JOB 35-1195
Comanche Peak Steam Electric Station

Construction Procedure
DOCUMENT CHANGE NOTICE NUMBER 7

This notice applies to Construction Procedure No. 35-1195- CCP-30 Revision 10.
This change will be incorporated in the next revision of the procedure.

BROWN & ROOT, INC. CPSES JOB 35-1195	PROCEDURE NUMBER	REVISION	EFFECTIVE DATE	ARMS INDEXED PAGE
	CCP-30	10	1/26/82	1 of 13
TITLE: COATING STEEL SUB- STRATES INSIDE REACTOR BUILDING AND RADIATION AREAS	ORIGINATOR:	<i>Mark L. Liles</i>		1-23-82 DATE
	REVIEWED BY:	<i>N/A RMD</i>		1-23-82 DATE
		<i>R. C. Cummings</i> B&R QA TUGCO QA		1-23-82 DATE
	APPROVED BY	<i>Charles S. S. S.</i> CONSTRUCTION PROJECT MANAGER		1-24-82 DATE

Attachment 3
CZ-11 CURE TO TOPCOAT TIME
25-50% R. H.

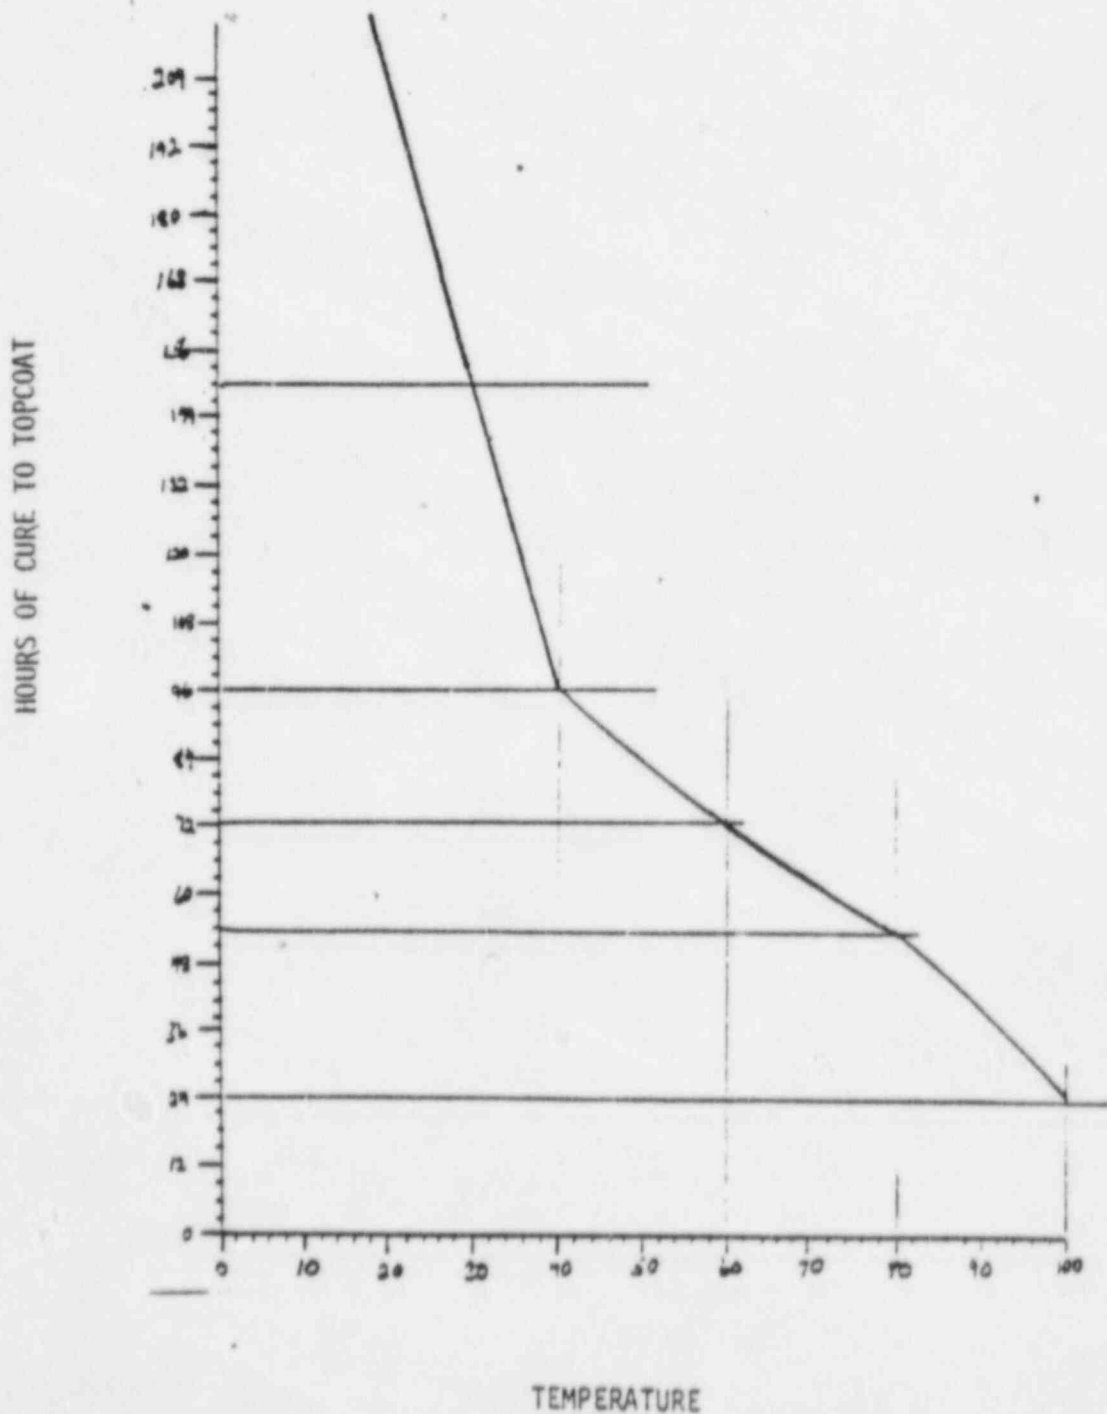
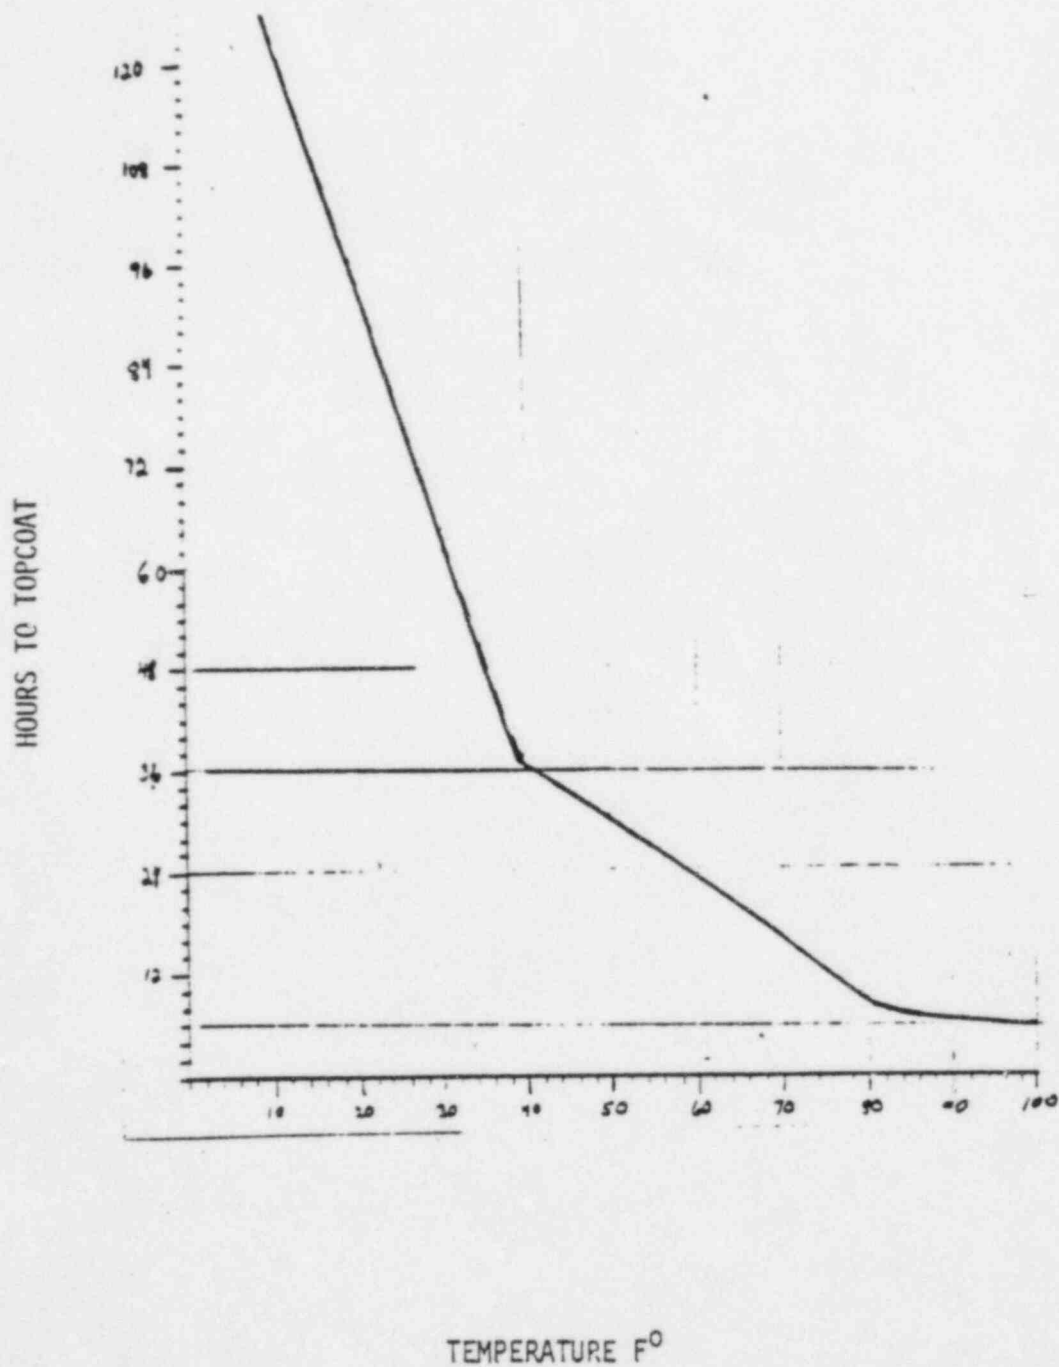
Replace the following pages with the attached:

Page 8 of 13
Attachment 3 Page 1 of 2
Attachment 3 Page 2 of 2

ATTACHMENT 4

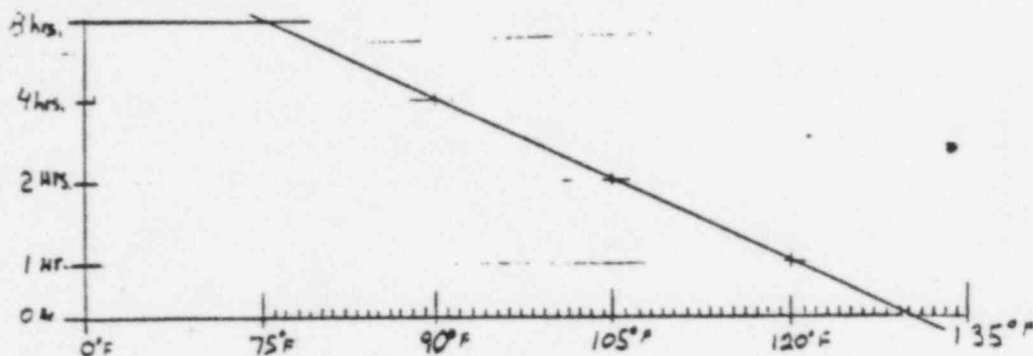
Replace the following pages with the attached:

Page 11 of 13
Page 12 of 13
Page 1 of 1 Attachment 4

Reason for change: Additional requirements
